| Office Action Summary | Application No. 10/714,265 | Applicant(s) LADOUCEUR, HAROLD A. | |

DETAILED ACTION

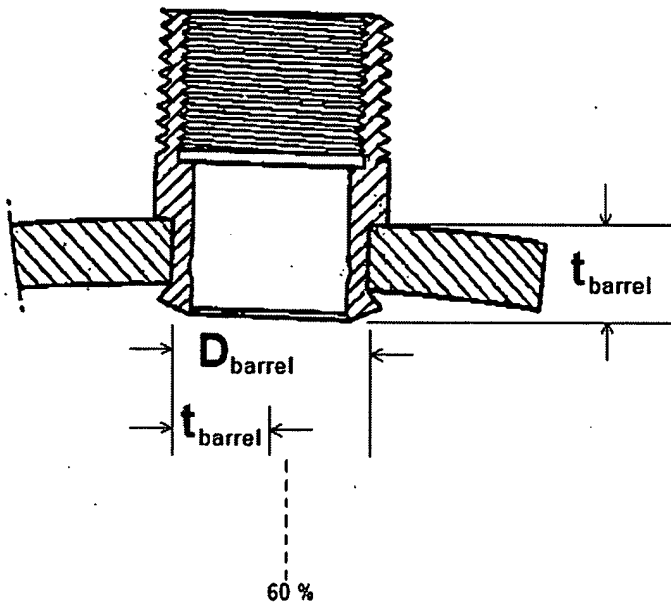
Foster et al. DOES teach each and every limitation found in the instant claim 1, including the specific relative size limitation *"said tubular barrel portion has an axial length equal to or less than sixty percent of an outer diameter of said generally cylindrical outer surface of said tubular barrel portion"* as shown in the figure below:

However, Applicant has amended claim 1 such that the Foster et al. reference fails to anticipate the added relative hardness limitation (greater than Rockwell C 30). Consequently, upon further consideration, a new ground(s) of rejection necessitated by amendment is made below.

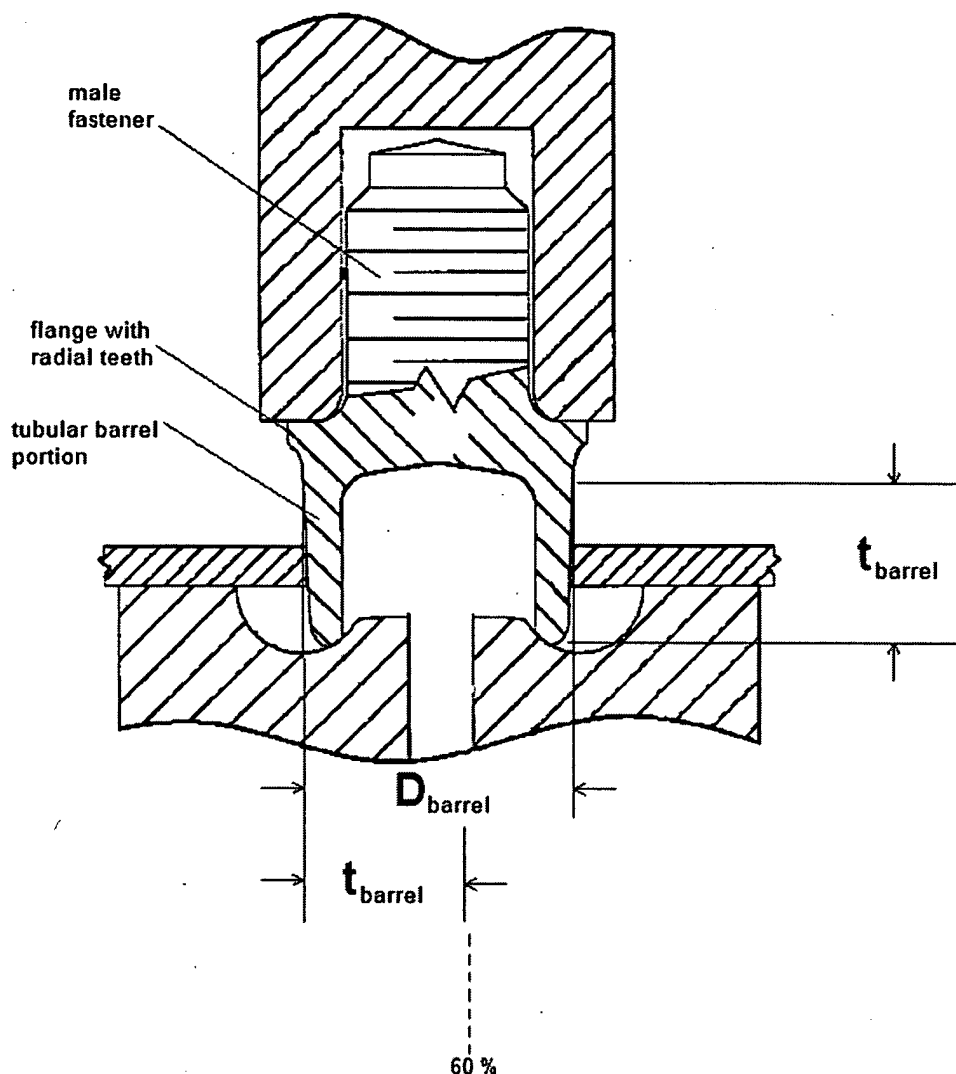
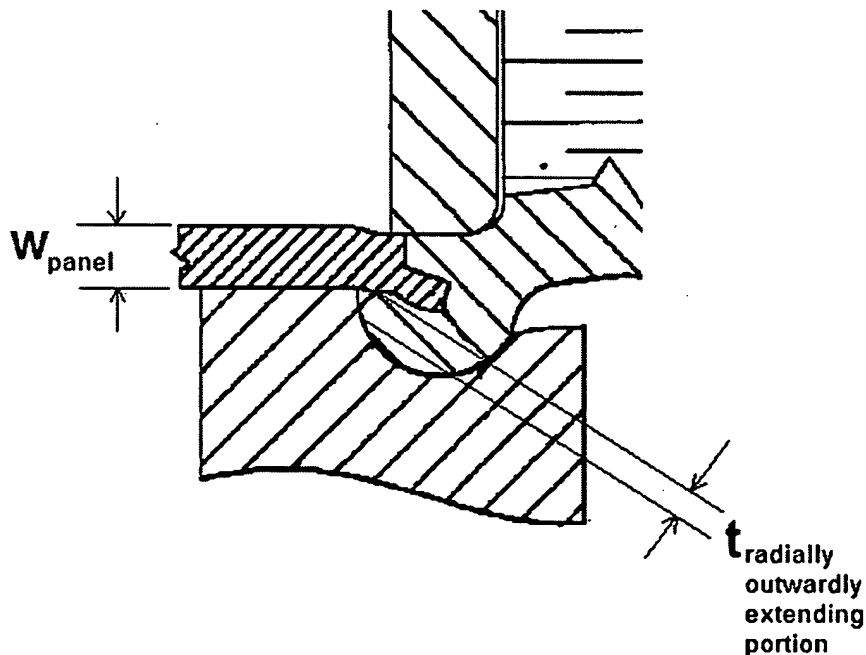
The disclosure set forth in US-5,868,535 would suggest to someone ordinarily skilled, a male fastener having the limitations in claims 1 and 3-21. As for the relative size limitation, Ladouceur (although not expressly in the specification) depicts a male fastener having a *"tubular barrel portion has an axial length equal to or less than sixty percent of an outer diameter of said generally cylindrical outer surface of said tubular barrel portion"*

With regard to Applicant's argument on the bottom of page 12 remarks, that *"the outer surface of the barrel portion [taught by Ladoucer] is not cylindrical"*, Applicant is directed to column 4 line 66 - column 5 line 1 of the '535 patent, which states: *"The tubular riveting portion 22 further includes an internal surface 38 and an external surface 40 which are generally cylindrical."*

With regard to Applicant's argument on the bottom of page 13 remarks, that *"there is no disclosure [in the Ladoucer '535 patent] of the preferred material from which the fastener is*

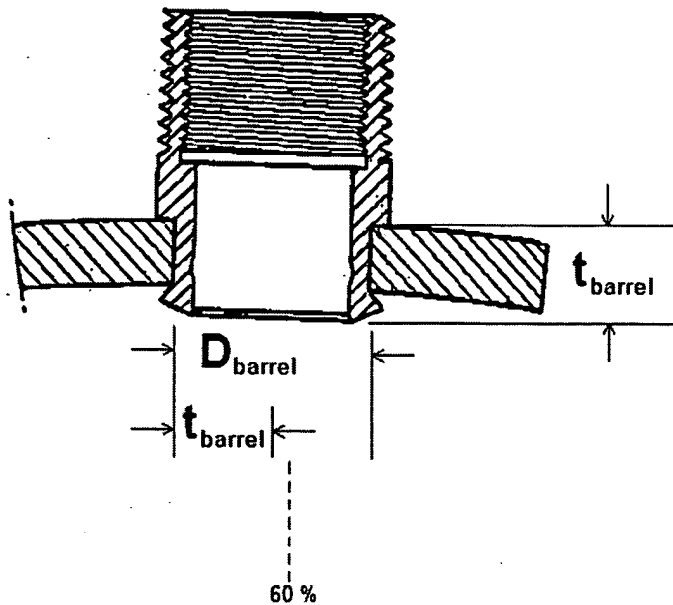
In short, Foster et al. teaches a male self-riveting fastener having a flange and a tubular barrel portion that is radially outwardly deflected. The fastener comprises the specific relative size limitation: *"said tubular barrel portion has an axial length equal to or less than sixty percent of an outer diameter of said generally cylindrical outer surface of said tubular barrel portion"* as shown in the figure below:

However, the Foster et al. reference is silent as to the hardness of the fastener.

At the time of invention it would have been obvious to one having an ordinary skill in the art, to make the fastener taught by Foster et al. greater than 30 Rockwell on the C scale, in order to prevent thread stripping which is common with softer metals.
